### Global Response GR-6

#### Alternatives

A number of commenters stated that the Draft EIR should consider additional alternatives to the JVR Energy Park Project (Proposed Project) and suggested alternatives that would purportedly reduce the Proposed Project's significant and unavoidable impacts to aesthetic and visual resources.

SOURCE: Leighton 2021; SANGIS 2017, 2021

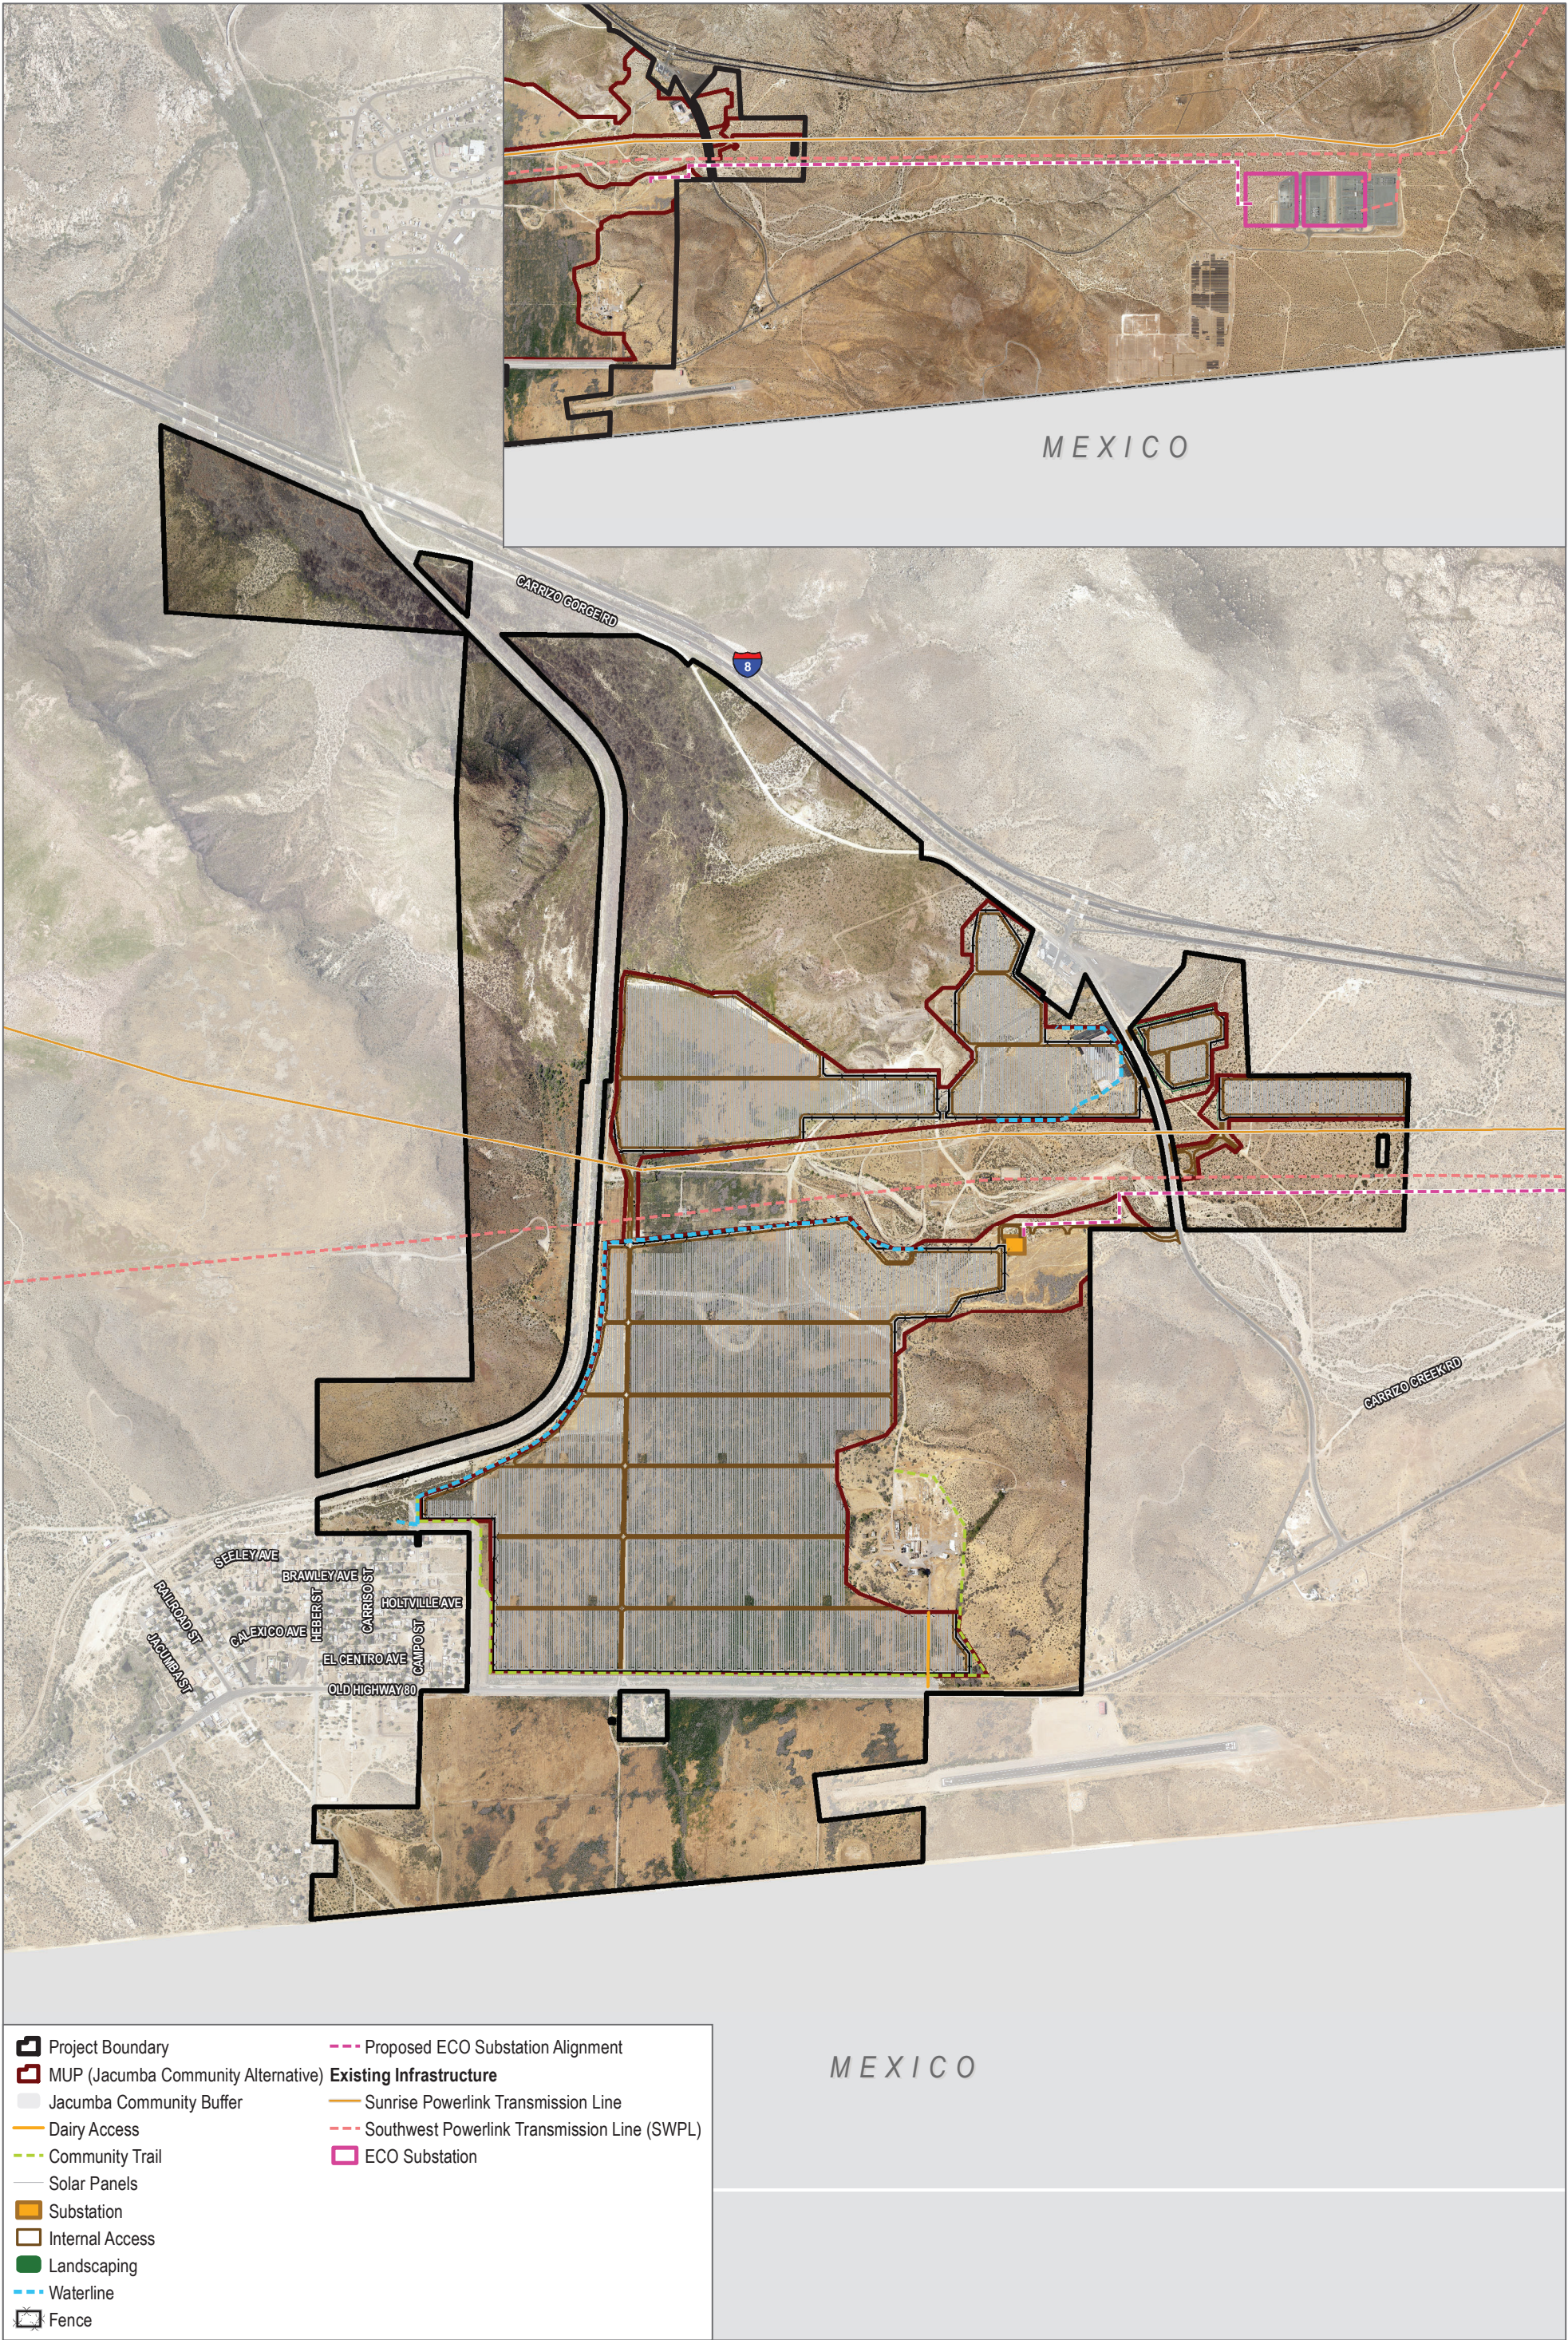
While the Draft EIR analyzed a reasonable range of alternatives and satisfied the requirements of CEQA, commenters proposed three additional alternatives: Reduced Project-Northern Focus Alternative; Jacumba Community Alternative; and the Reduced Panel Height Alternative. These additional alternatives are discussed further below.

However, a block of habitat could be considered that would satisfy the Northern Focus Alternative’s biological mitigation requirements and minimize impacts to mineral resources as shown in Figure GR-6-6. This block of habitat would preserve 138.95 acres of habitat along the western edge of the Project site. This would build upon the existing preserved lands to the west of the Proposed Project and would not result in the preservation of fragmented habitat. This would also aid in the preservation of the wildlife corridor which runs north to south on the west side of the Proposed Project. However, this biological open space easement (See Figure GR-6-6) would result in impacts to 68.3 acres of mineral resources.

As such under the Northern Focus Alternative, a total of 68.3 acres of significant mineral resources would no longer be able to be mined. This represents an approximate loss of 6,545,326 tons of potential sand and aggregate, which would amount to \$78,543,900 and greatly exceed the County’s minimum value threshold of \$12,500,000. In other words, the Reduced Project– Northern Focus Alternative would require habitat mitigation (**M-BI-3**) that would cause a significant and unavoidable impact to mineral resources, although this impact would be less than the Proposed Project.
